Application No. 10/711,904 Examiner: Shih-Chao Chen

Filed: October 12, 2004 Art Unit: 2821

Amendments to the Drawings:

Application No. 10/711,904 Amdt. Dated April 3, 2007 Reply to Office Action of January 3, 2007 Annotated Sheet Showing Changes

Fig. 3

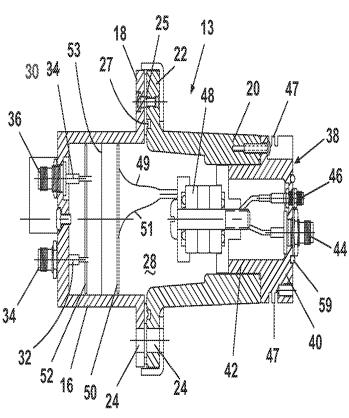
The attached sheet of drawings includes changes to Fig. 3. This sheet replaces the original sheet including Figs. 3 and 4. In Fig. 3, numeral 34 directed to the lead line has been changed to 30.

The drawings stand objected to on various grounds. The objection is traversed. The Examiner asserts that element 34, shown in Figure 3, refers to both the cable lead and the connector. Fig. 3 has been amended to properly reflect the subject cable lead with the reference number 30, as indicated in paragraph [41] of the application.
